SIGHT LINE ANALYSIS (Revised)

Proposed Townhouse Development
1110 Lorne Park Road
Mississauga, ON

Re: **Proposed Townhouse Development, 1110 Lorne Park Road, Mississauga, ON - Sight Line Analysis (Revised)**

Figure 2: Site Plan

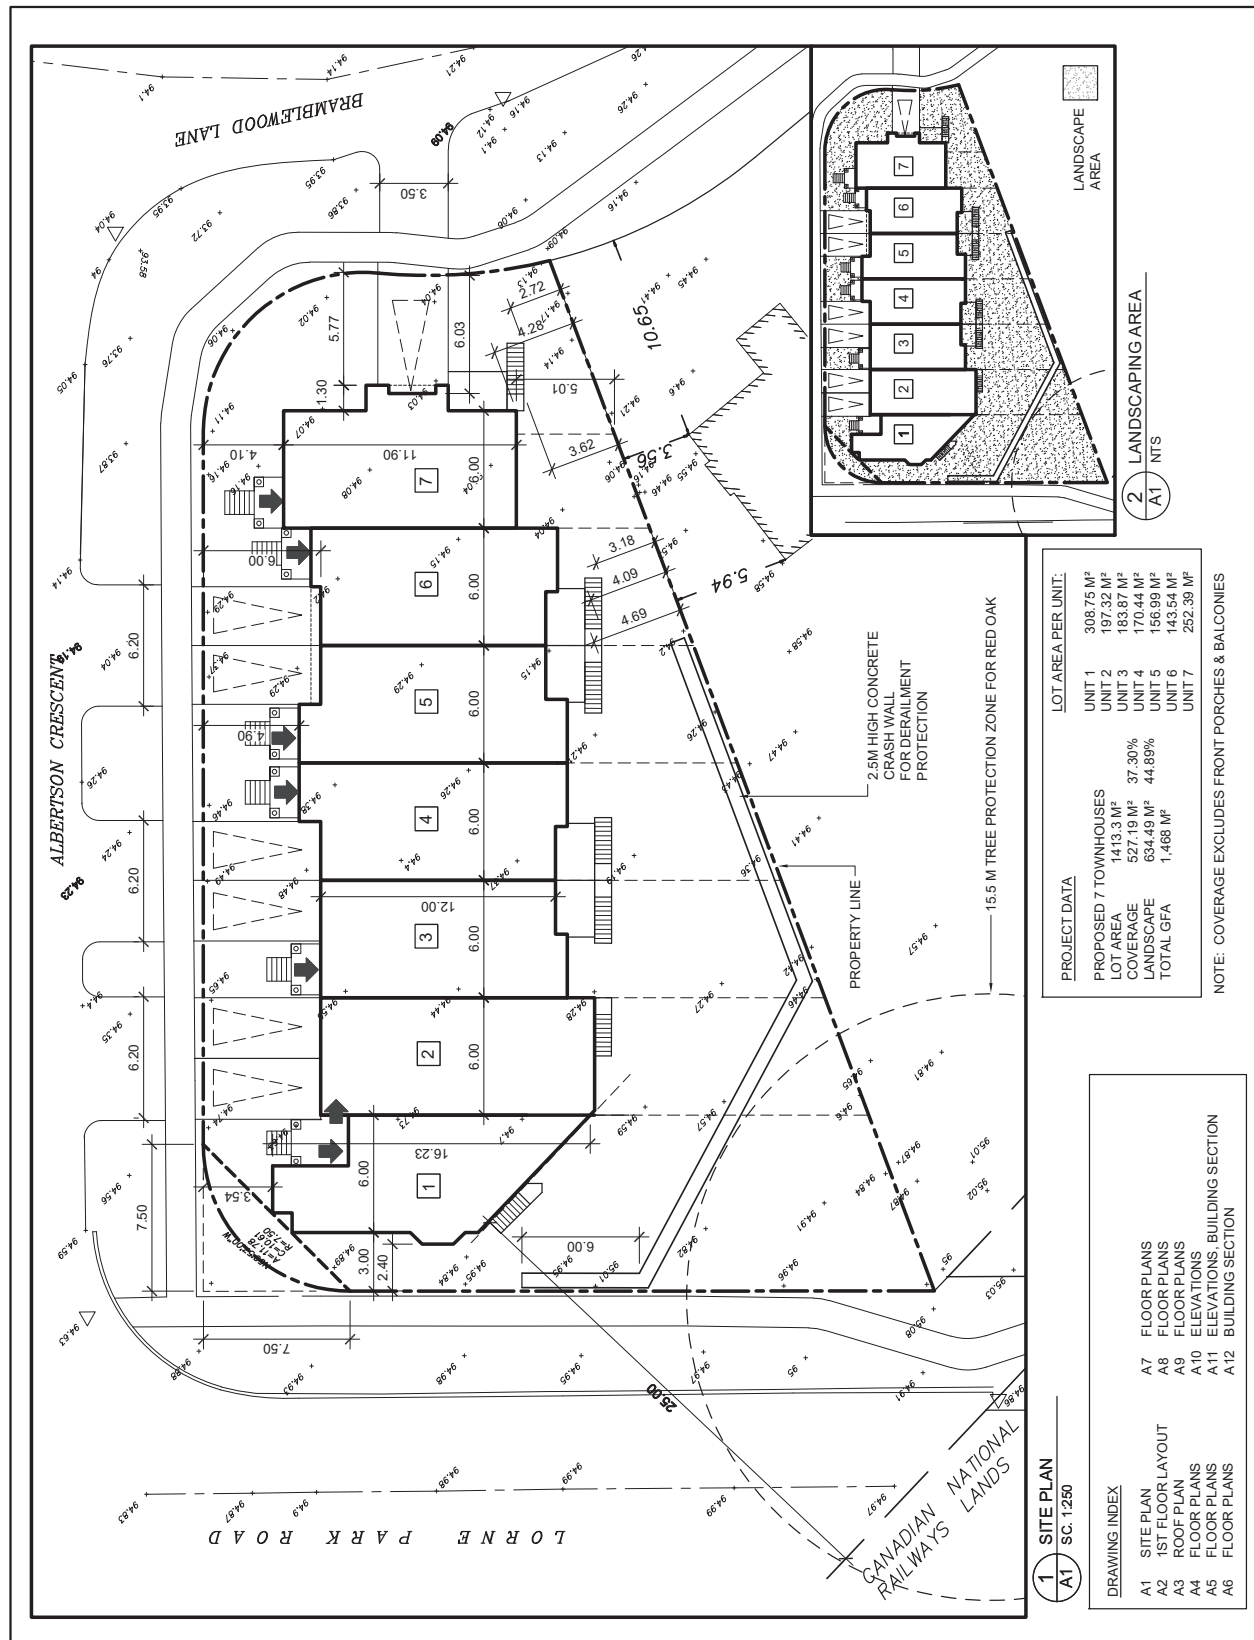
Comment 2: Please clarify if a wooden acoustic (or other) fence is contemplated along Lorne Park Road and, if yes, have impacts to sightlines associated with same been assessed?

As shown in Figure 2, the proposed 6m crash wall does not encroach within the sight triangle, and driver sightline visibility is maintained. Driver visibility would be impacted if the crash wall were extended any further east on Lorne Park Road other than as shown on the site plan.

A wooden acoustic (or other) fence, located within the departure sight triangle along Lorne Park Road, would most likely have the same impact in terms of sightline, unless the decorative fence was fairly low in height (0.5m or less).

Figure 3 - Departure Sight Triangle, Passenger Car

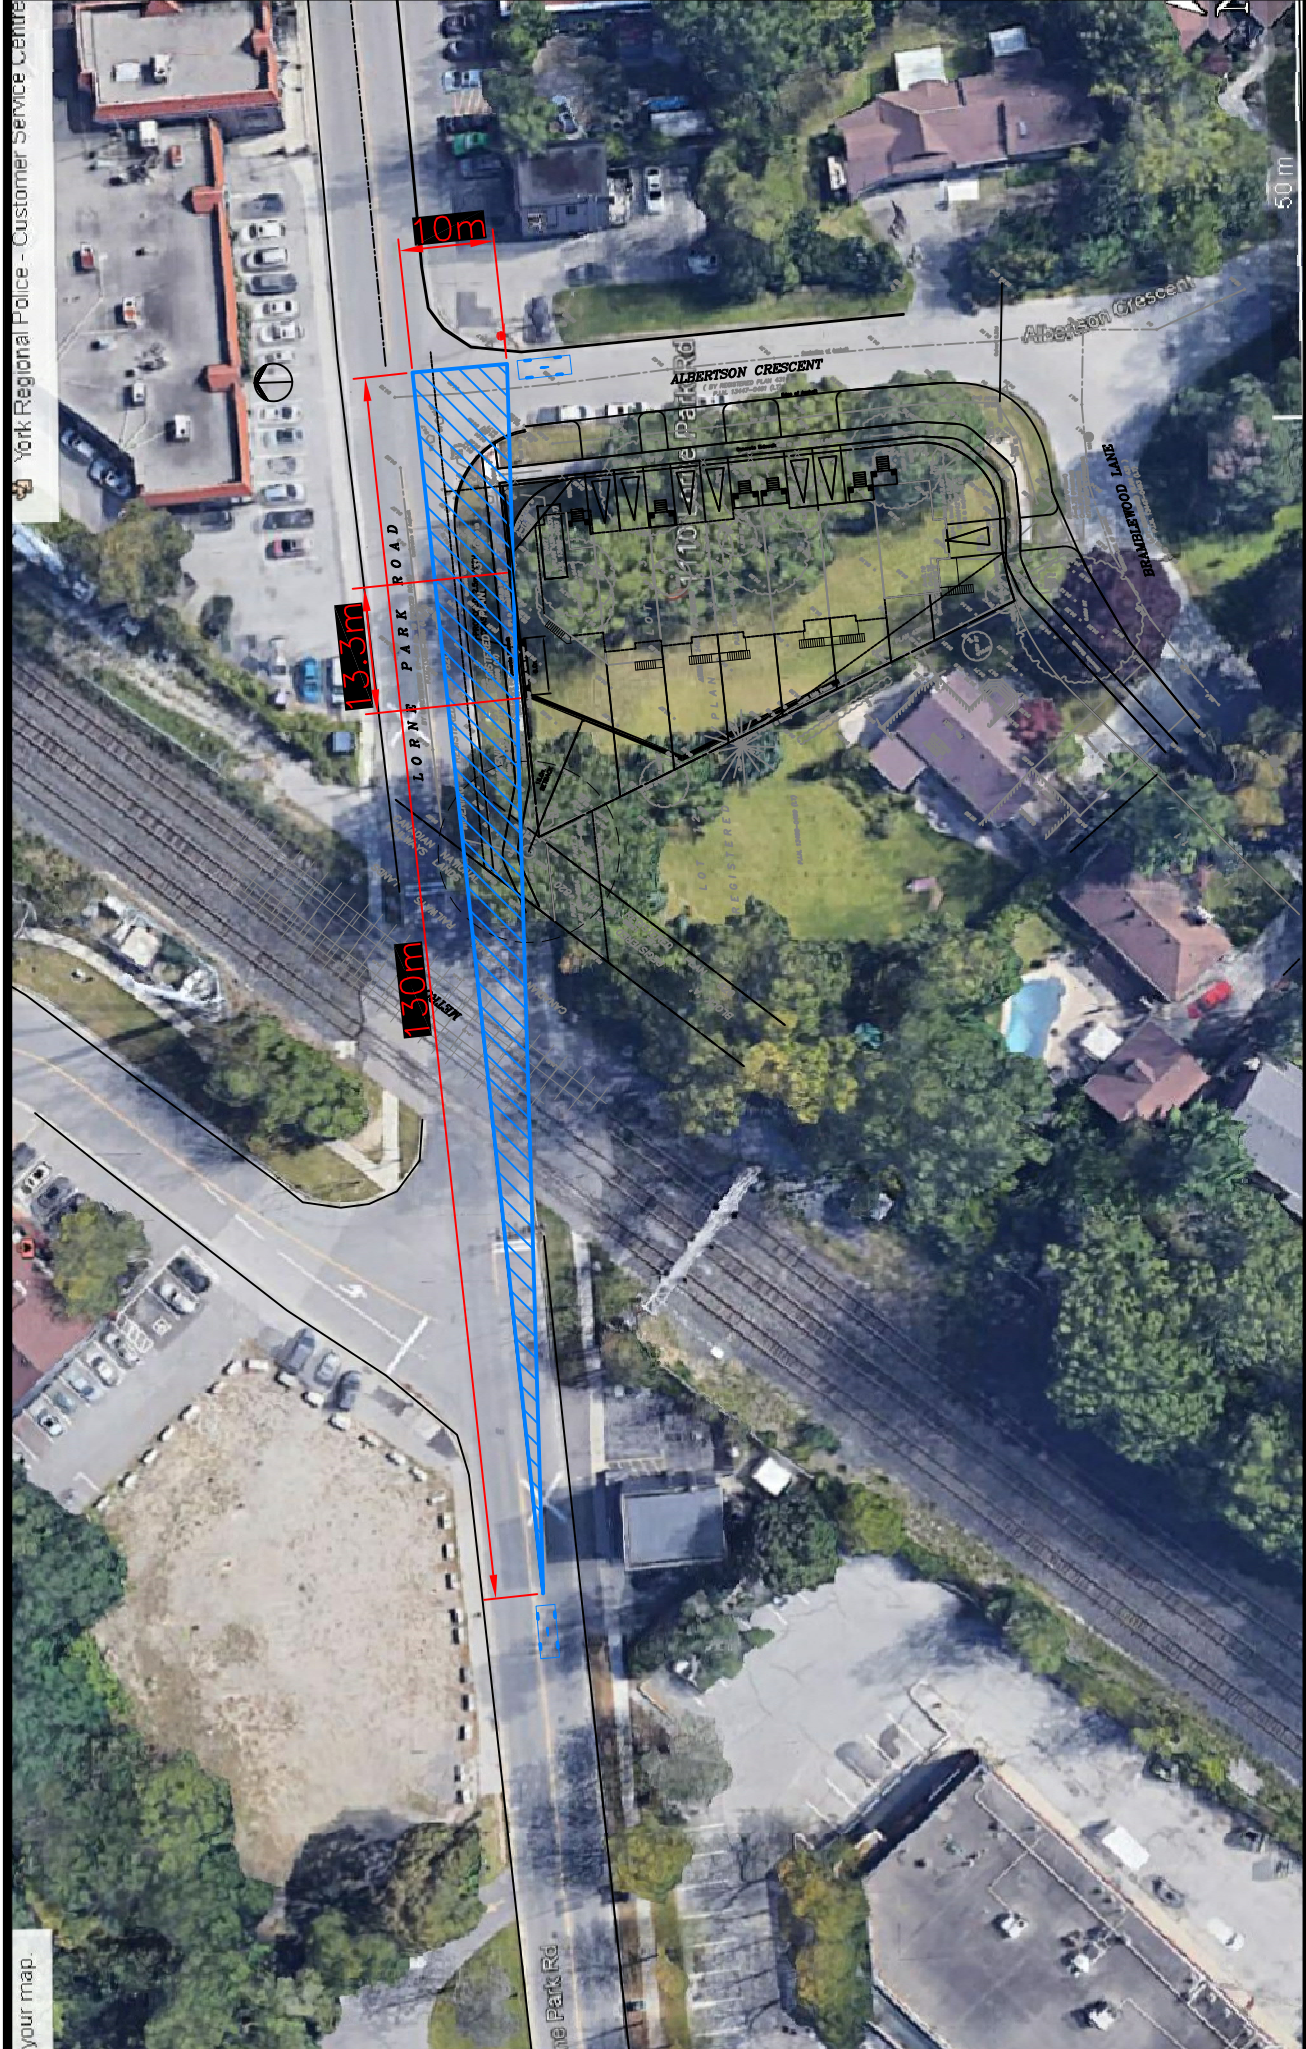
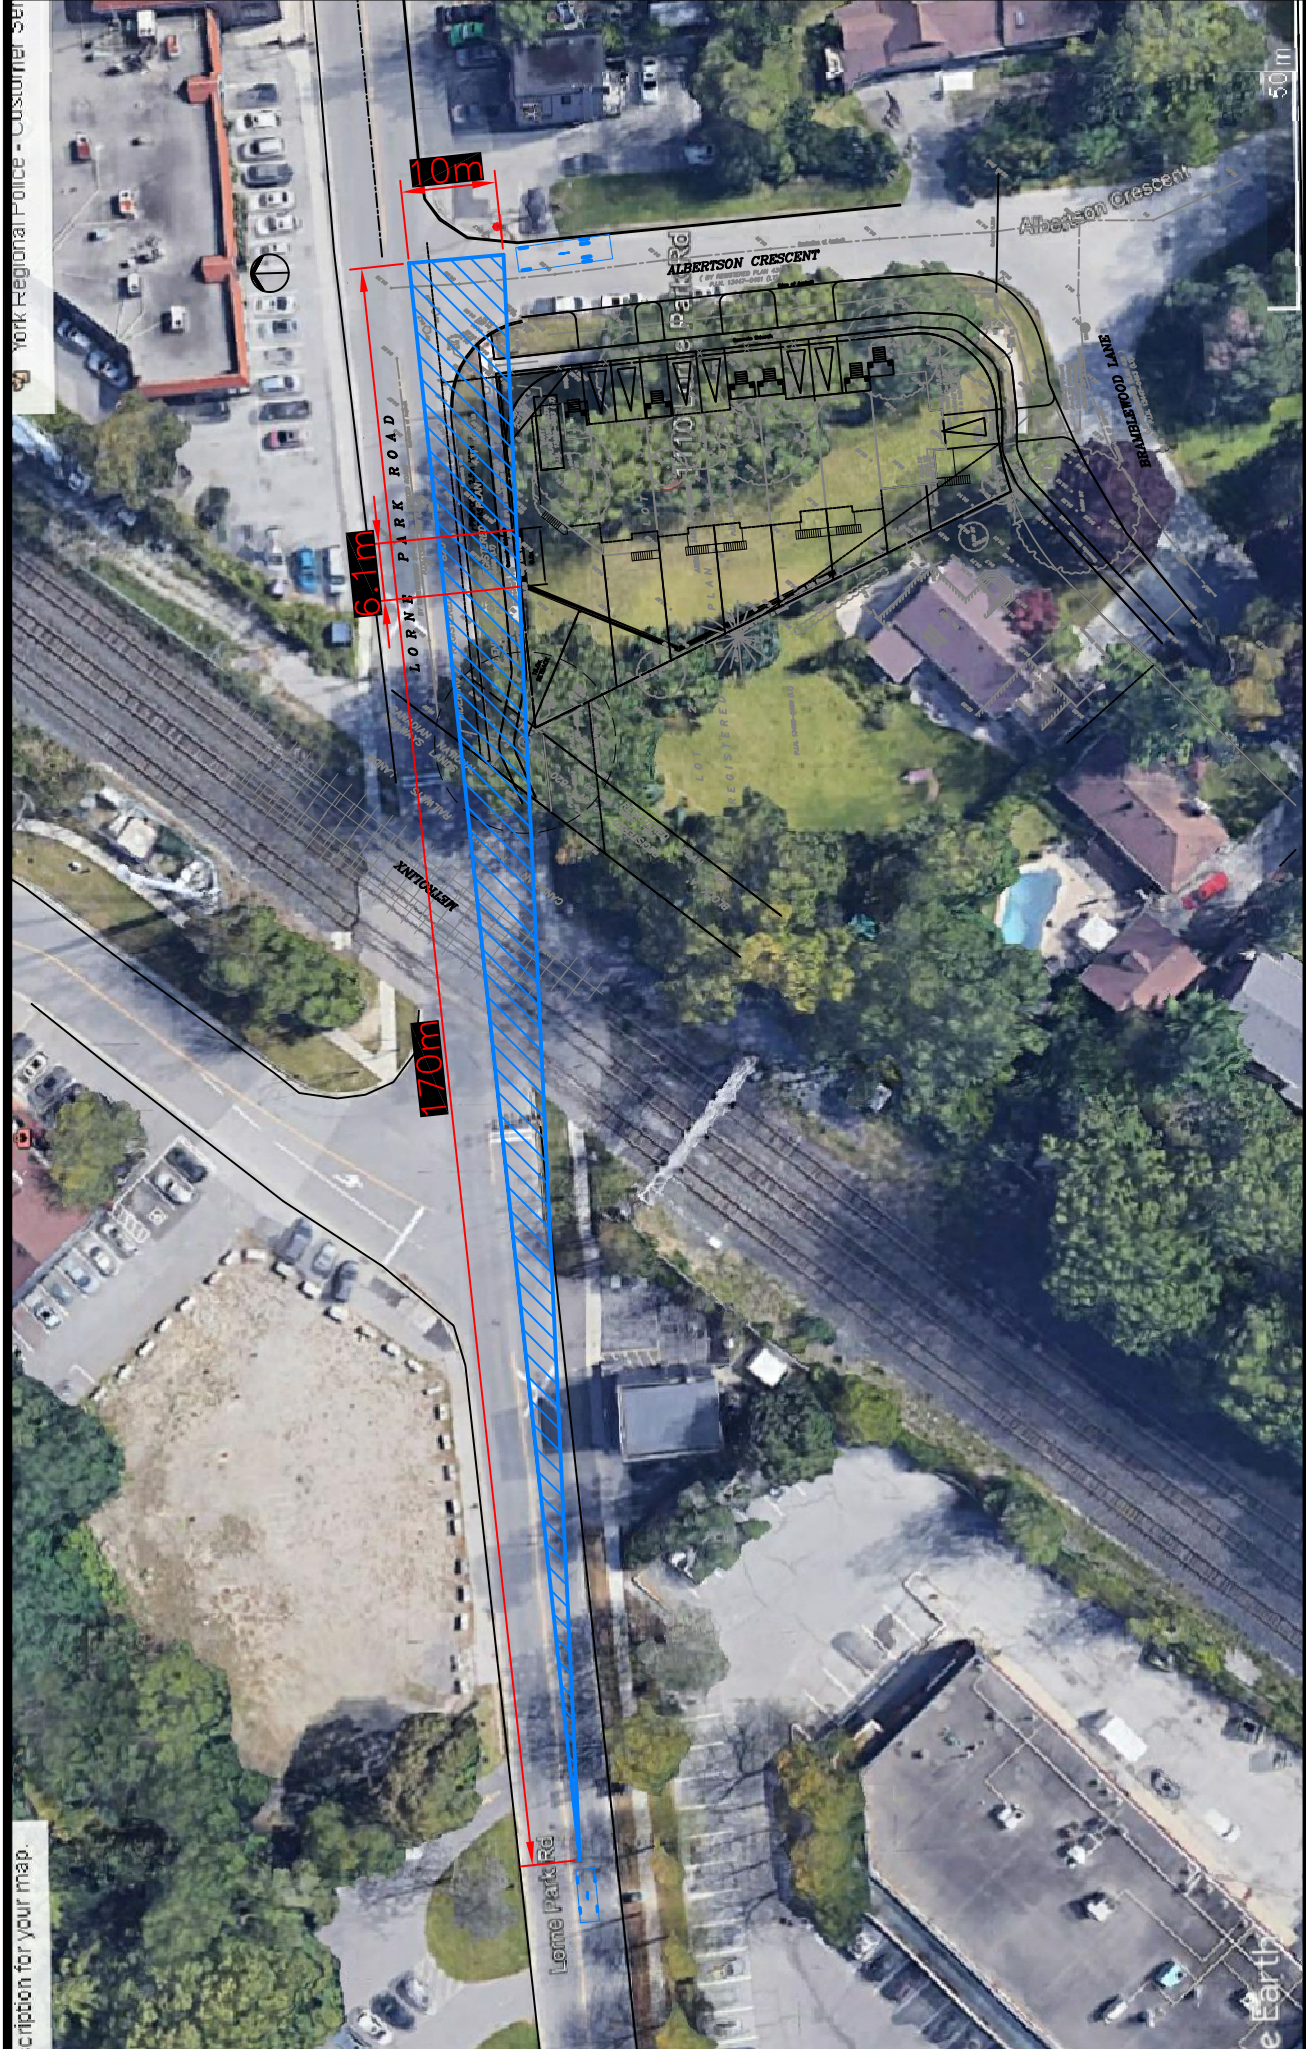
Comment 1: Section 5.3 of the subject Sight Line Analysis notes that "there might be negative impact on the visibility for vehicles travelling north on Albertson Crescent, looking west on Lorne Avenue" due to the presence of a crash wall – with degree of impact based on "the height, thickness and location" of the crash wall. As this analysis is not complete, it cannot be concluded that installation of a crash wall is not possible. Based on a cursory analysis of prevailing circumstances it would appear there are limited if any concerns in this regard. The analysis should be updated to fully assess the implications of a crash wall along the edge of Unit 1 assuming design parameters akin to the wall that has already been designed for this site.

An assessment of sightline at the intersection of Lorne Park Road and Albertson Crescent has been conducted. The results and conclusions have been provided in Table 3, Figure 3-4 and Section 6.4. Based on TAC guidelines, our review of the departure triangle at Lorne Park Road and Albertson Crescent (west leg), looking west, a crash wall shorter than 6.1m along Lorne Park Road is recommended.

The results indicate that the crash wall should not be extended more than 13.3m along Lorne Park Road when passenger vehicle is considered as design vehicle. However, when a single-unit truck is considered as the design vehicle, the crash wall could be 6.1m or less in length. To be conservative, we recommend a crash wall length of 6.1m to provide clear departure sight length for a single-unit truck.
